Service Bulletin

This service bulletin replaces SB25-14.

Subject: Float Switch Clip, Float Inspections & Troubleshooting

Models: FQG60T, FQG80T, FQG100T & FQG120T Touch Screen Fryers

Figure 3 Float switch showing E-clip.

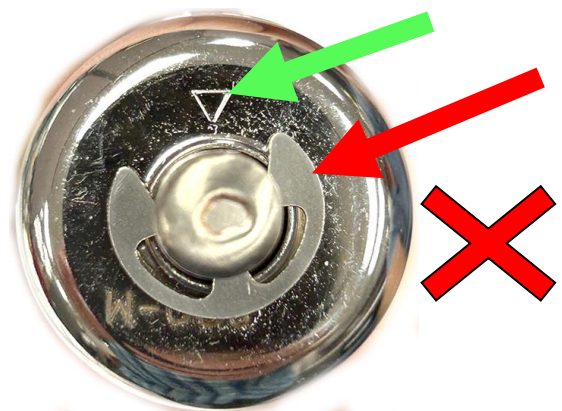
1. If the float switch has a **HEAVY-DUTY GRIP RING** supplied by the manufacturer on **TOP OF THE FLOAT** **AND** a **HEAVY-DUTY GRIP RING BELOW THE FLOAT** (see Figure 1), the float is good stock and **DOES NOT NEED TO BE REPLACED**.
2. If the float switch has an **INDENTED TRIANGLE ON THE TOP OF THE FLOAT** (see Figure 2), it **MUST** have **GRIP RINGS** on the **TOP & BOTTOM OF THE FLOAT** (see Figure 1). If it has **E-clips** on **TOP & BOTTOM OF THE FLOAT** (see Figure 3), the **E-clips** **MUST BE REPLACED** with **GRIP RINGS**!

Figure 5 Float switch with E-Clip beneath the float that **DOES NOT** have a triangle on the top.

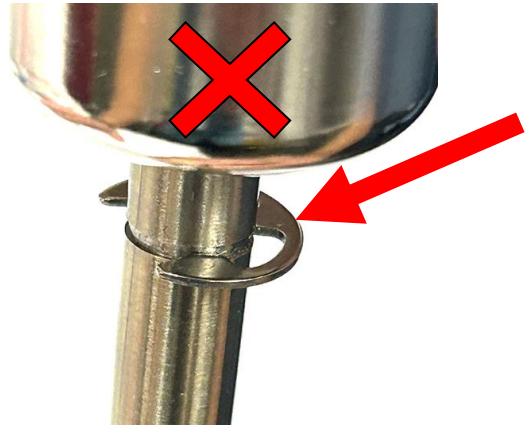
3. If the float **DOES NOT HAVE A TRIANGLE** on the **TOP OF THE FLOAT** (see Figure 4) **AND** it has an **E-clip BENEATH THE FLOAT** (see Figure 5), **IT MUST BE REPLACED** with kit PN 8262541!

Figure 6

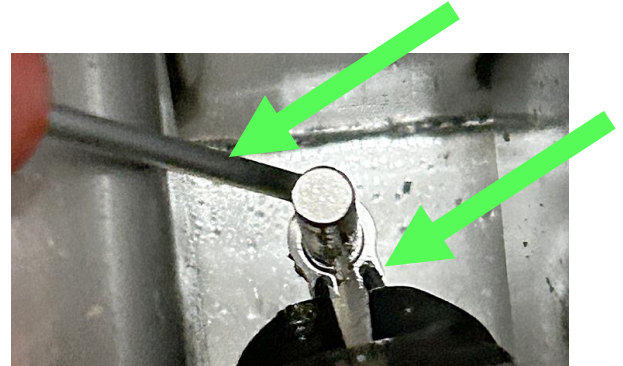
When installing the bottom grip ring, a screwdriver will be needed to gently push the grip ring down into the groove while holding the grip ring with Snap Ring pliers (see Figure 6).

Figure 7

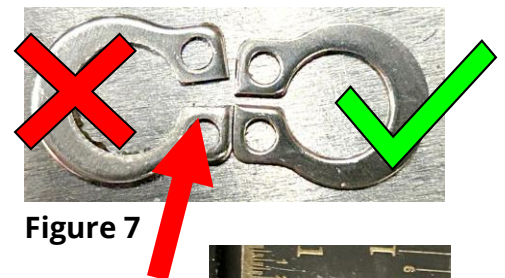
Ensure the grip ring is **NOT** deformed and loose on the shaft. It should fit tight into the groove. Figure 7 shows a deformed grip ring on the left and a normal grip ring on the right.

Figure 9

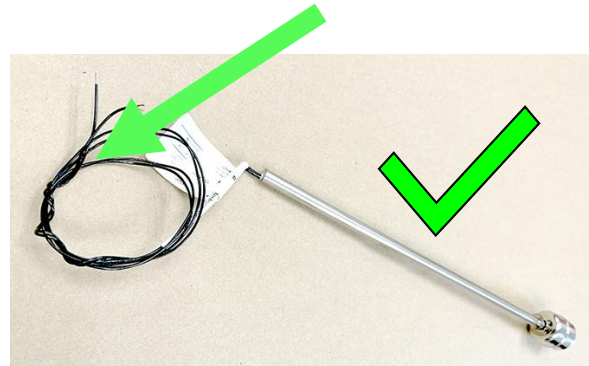
When replacing float switches with kit PN 8262541, ensure that **ONLY** float switches **WITH BLACK LEADS ONLY** (see Figure 9) are used as replacements.

Figure 10

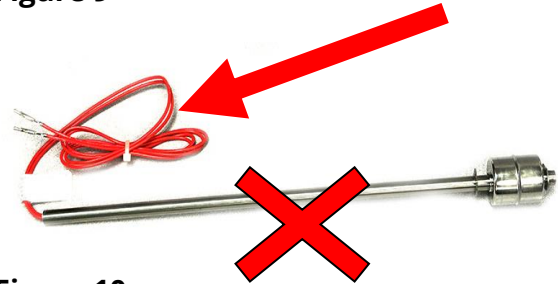
FAS's should order replacement kits first. Once they receive the new kits, they should return any 8262541 kits with **RED** leads (see Figure 10).

Figure 11

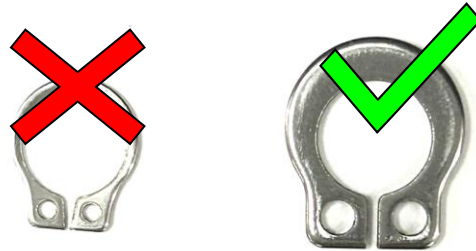
Standard snap rings **SHOULD NOT** be used (see snap ring on the left in Figure 11). They will not hold and will come loose.

ONLY HEAVY-DUTY GRIP RINGS from the manufacturer (see grip-ring on right in Figure 11) should be used.

Figure 12

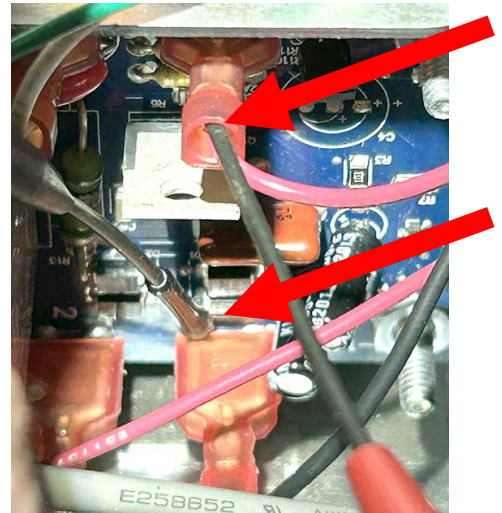
- i. Test across pins 1 (Red) & 12 (Black) (see Figures 12, 14 & 15). 24VDC should be present with the switch activated.
- ii. Test **across pins** 6 (Green) & 7 (White) or 2 & 3, depending which pins have Green and White wires attached (see Figures 13, 14 & 15). The voltage should be near 0VDC when activated. If the voltage is above 0.3VDC with power on and contacts closed, the time delay relay **MUST** be replaced.
